MEMORANDUM

Re: Modifications to Design Approval for the Kensington Tower at approximately 89 E. 200 S. (PLNPCM2019-00786)

REQUEST: The Kensington Tower project previously received Design Review approval from the Planning Commission on November 13, 2019. The applicant has requested modifications to the approved design. These changes are required by ordinance to be reviewed by the Planning Commission as only minor modifications can be approved administratively.

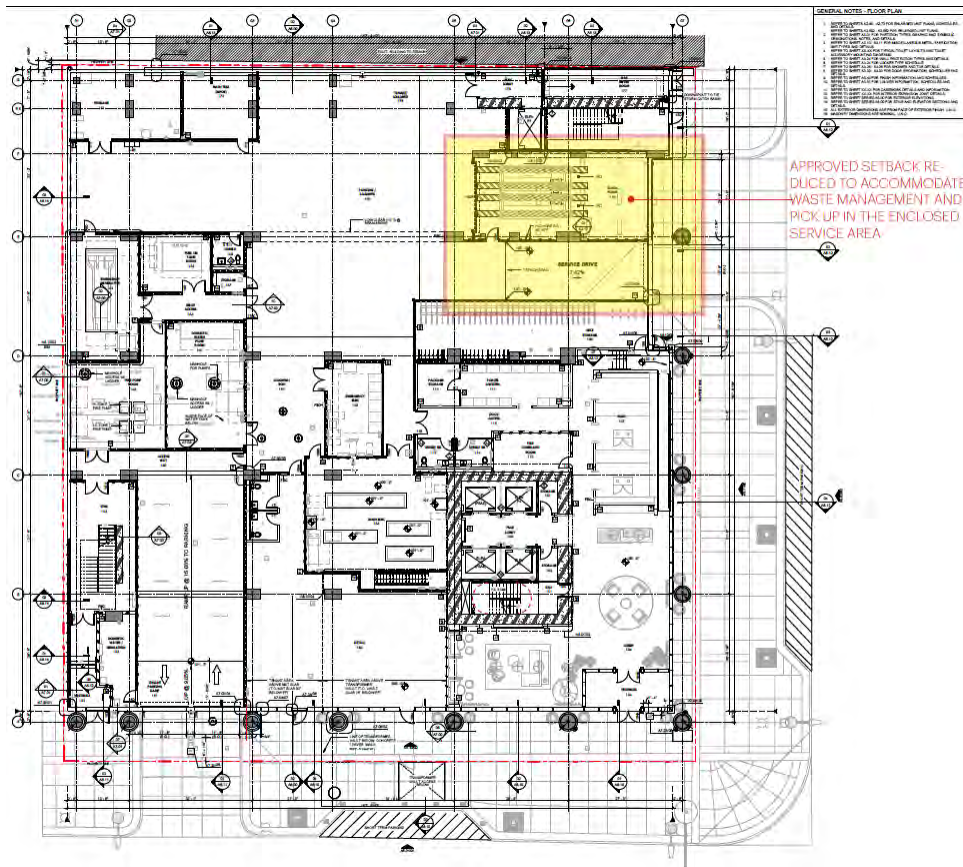
Modifications are also proposed for the west façade, the original proposal called for GFRC panels on the west side of the shorter, southwest massing of the structure approximately up to the eighth floor. The applicants are now requesting to utilize concrete masonry block along the same expanse. The proposal is being made in anticipation of future construction on the parcels to the west. It is highly likely that the section of the structure will be completely covered by new development.

The final proposed change to building materials is the potential to remove the canopy on the 22nd story of the structure that covers portions of the pool deck which is likely not visible from the street. The images below show the approved structure and the proposed structure with the new adjacent development as well as highlighting the canopy structure.

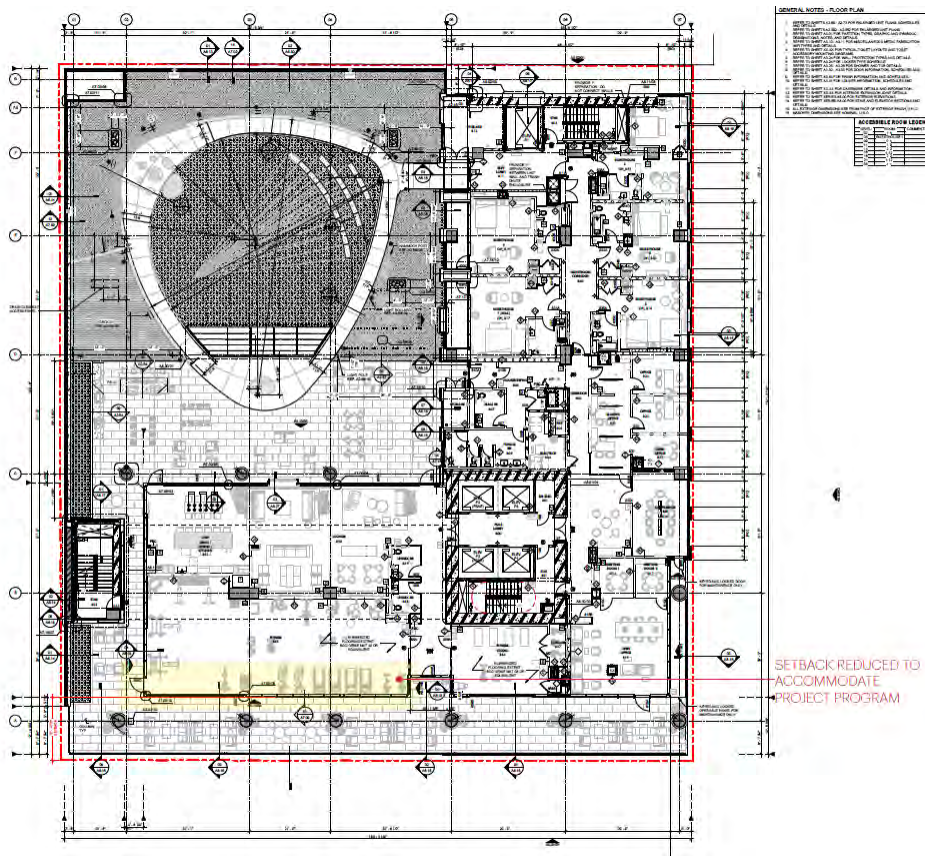
Along State St., the setbacks will remain the same as originally approved except on the northeast corner of the structure which was modified to better accommodate waste management for the site. The setback will be less than originally approved meaning it will better meet the maximum front or corner side yard setback in the D-1 district. The image below highlights the area of change.

SOUTH FACADE MODIFICATION

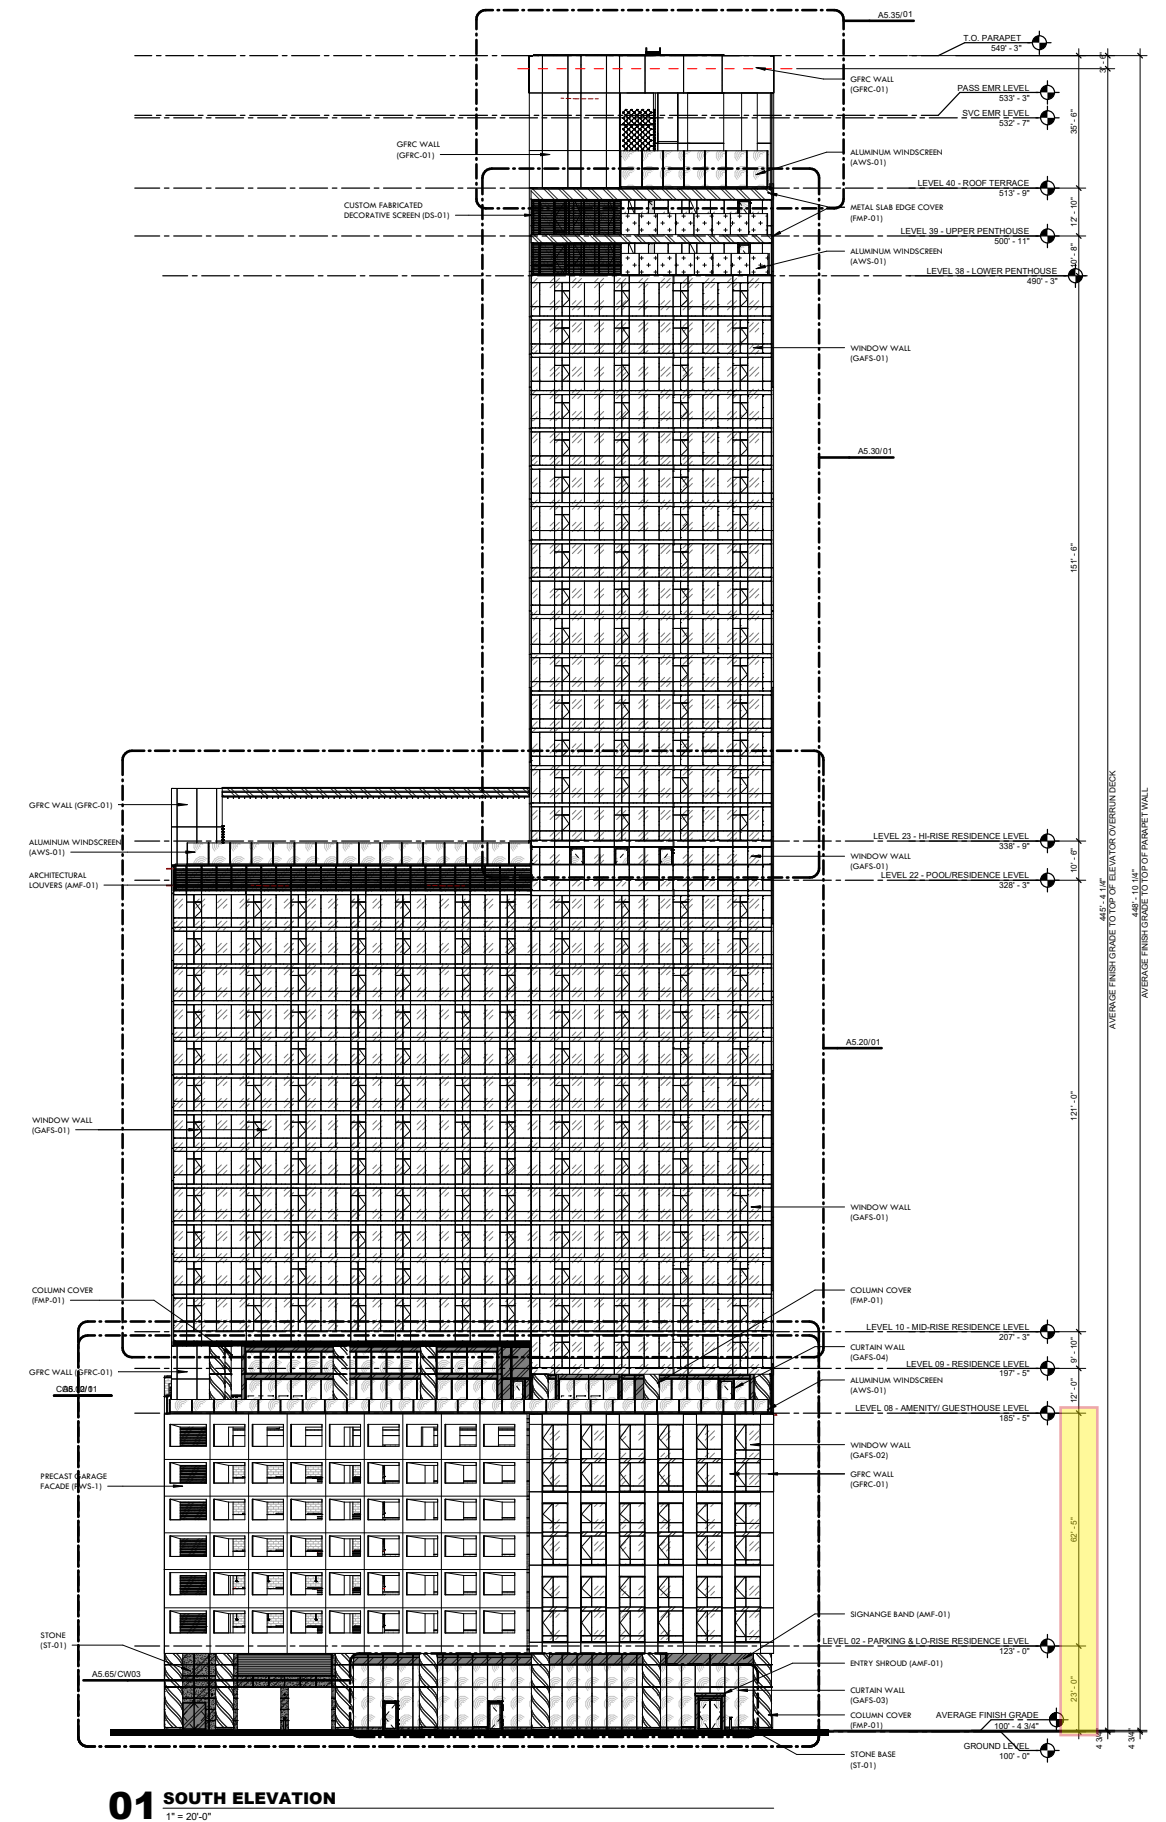
PHOTOVOLTAIC
FINS DELETED

WEST FACADE MODIFICATION

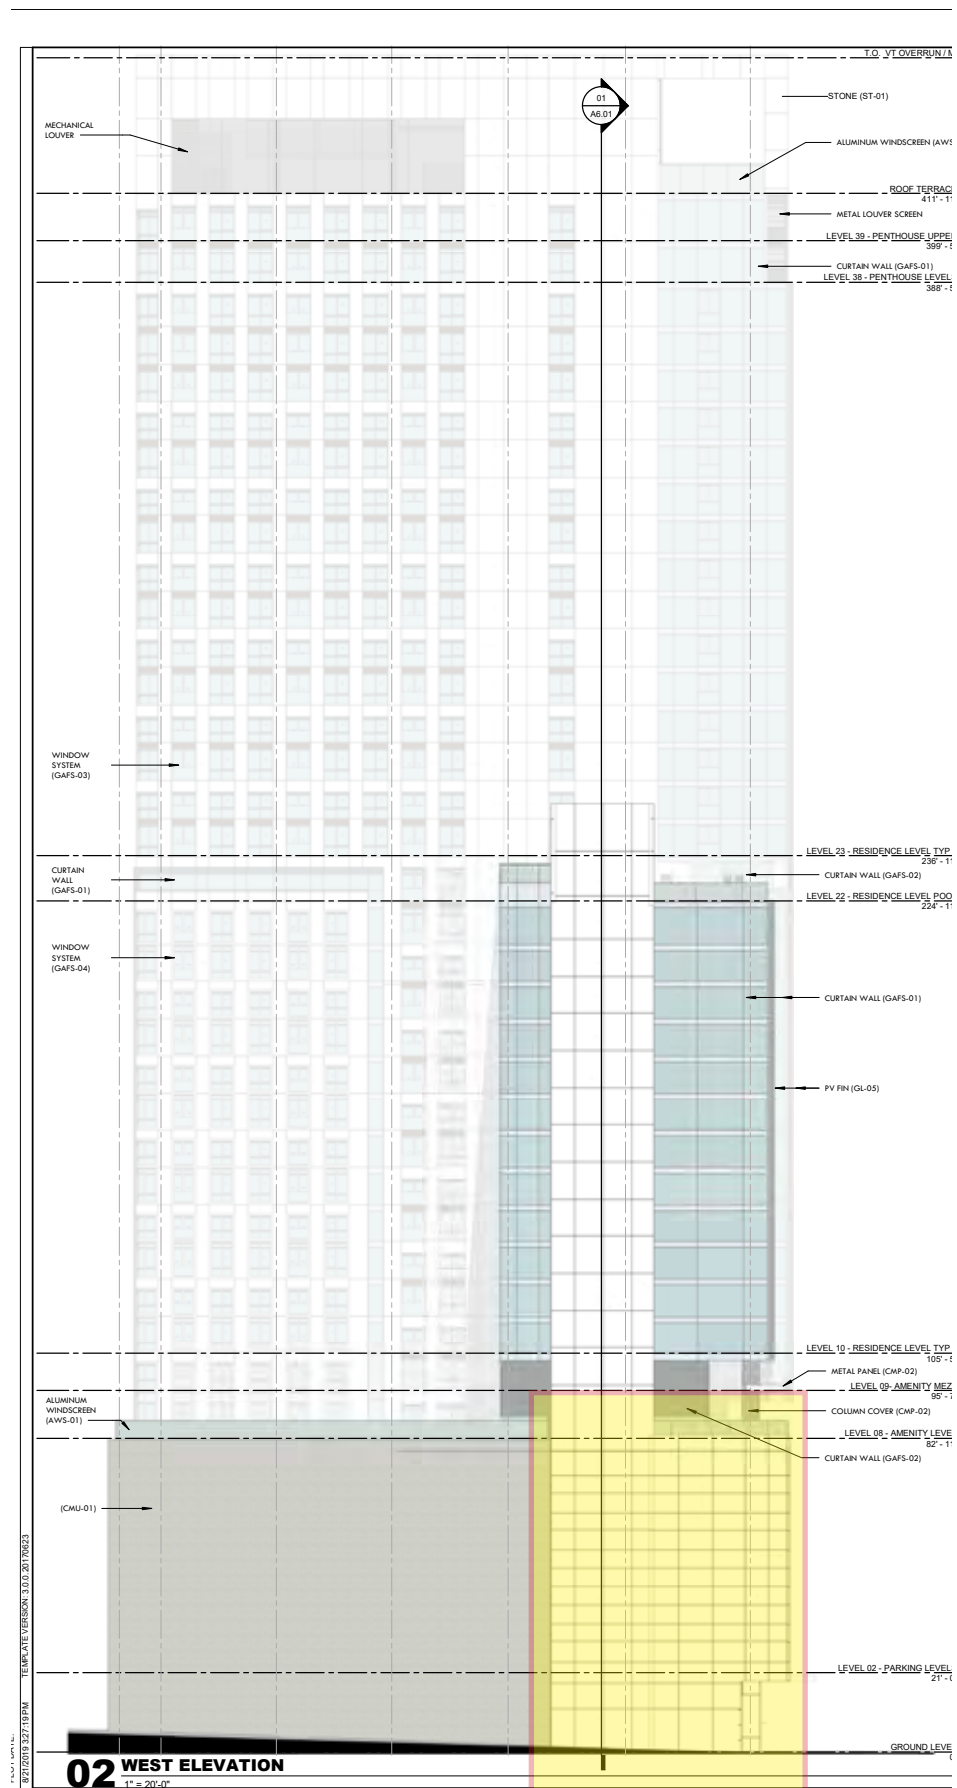
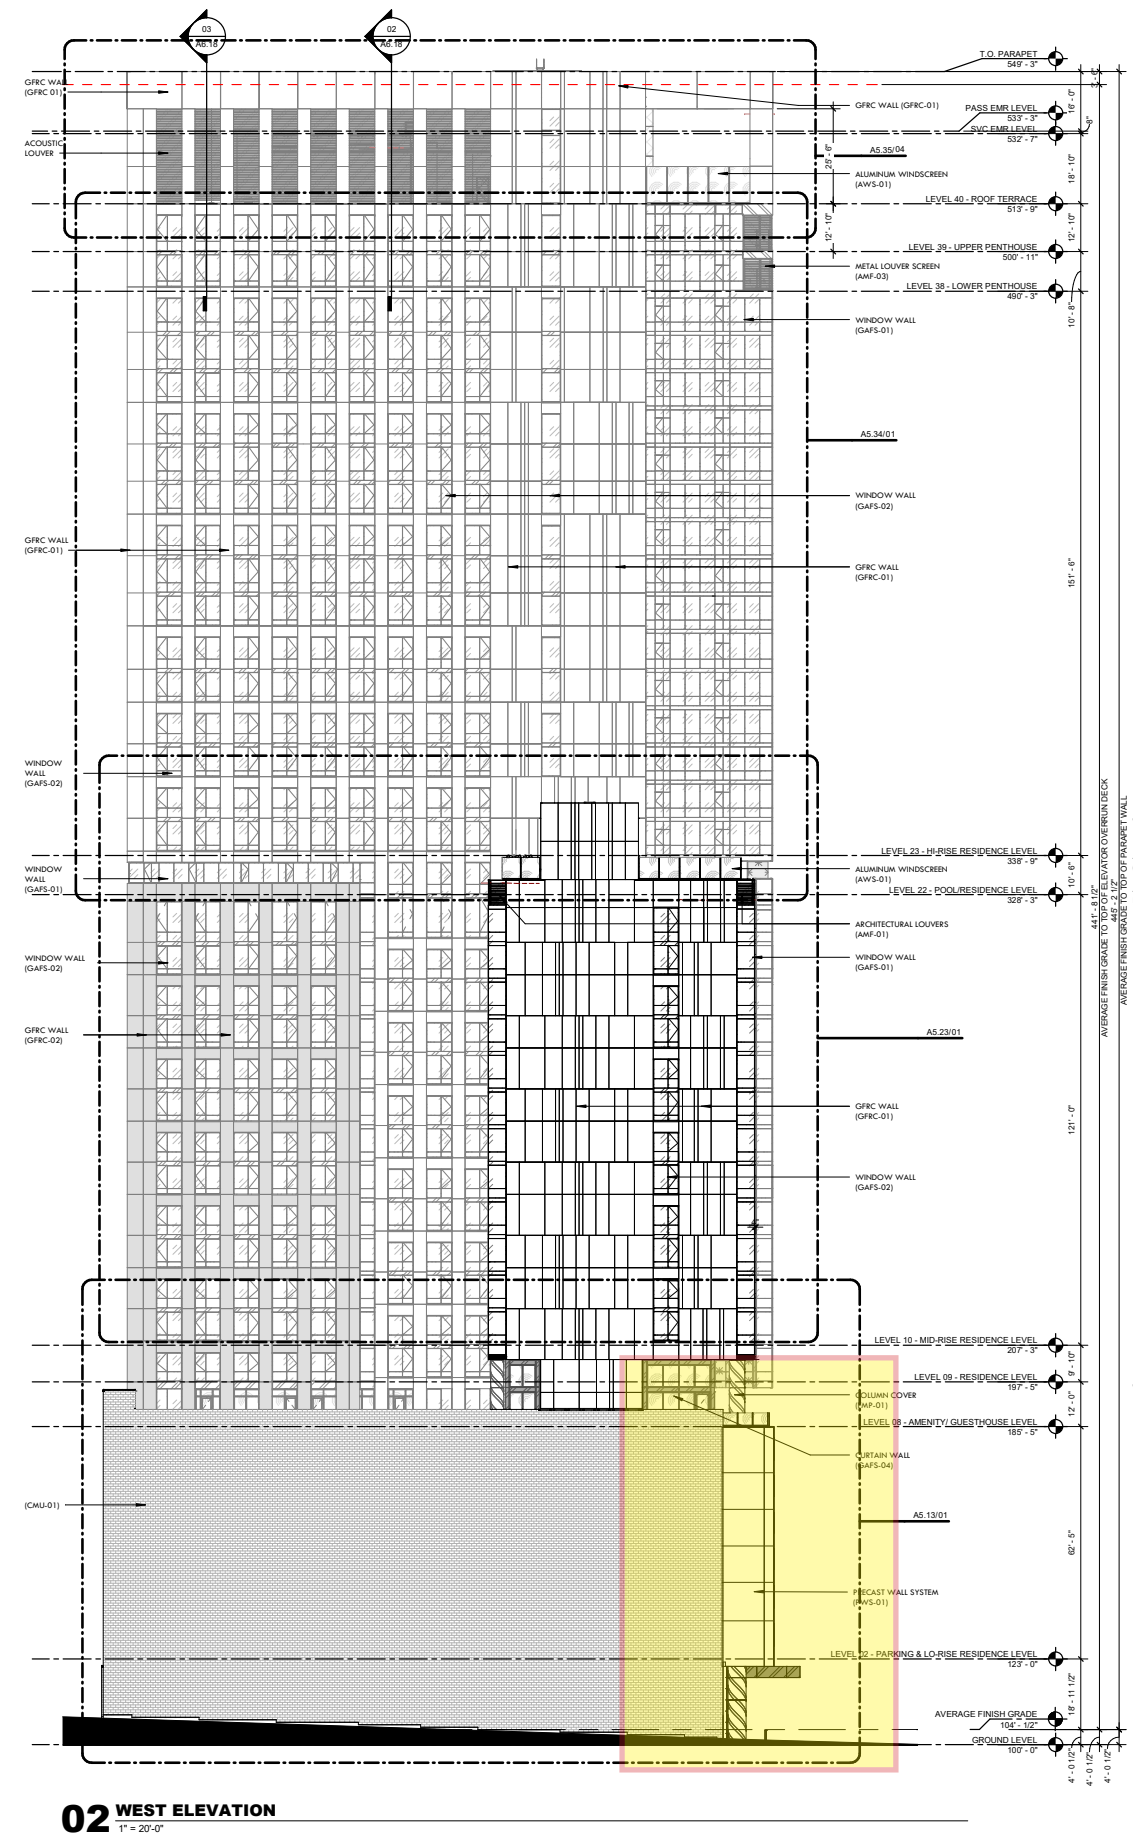
POOL DECK CANOPY CARRIED AS AN ADD ALTERNATE AND COULD BE POTENTIALLY DELETED

WEST FACADE ANTICIPATED TO BE COVERED BY ADJACENT PROJECT
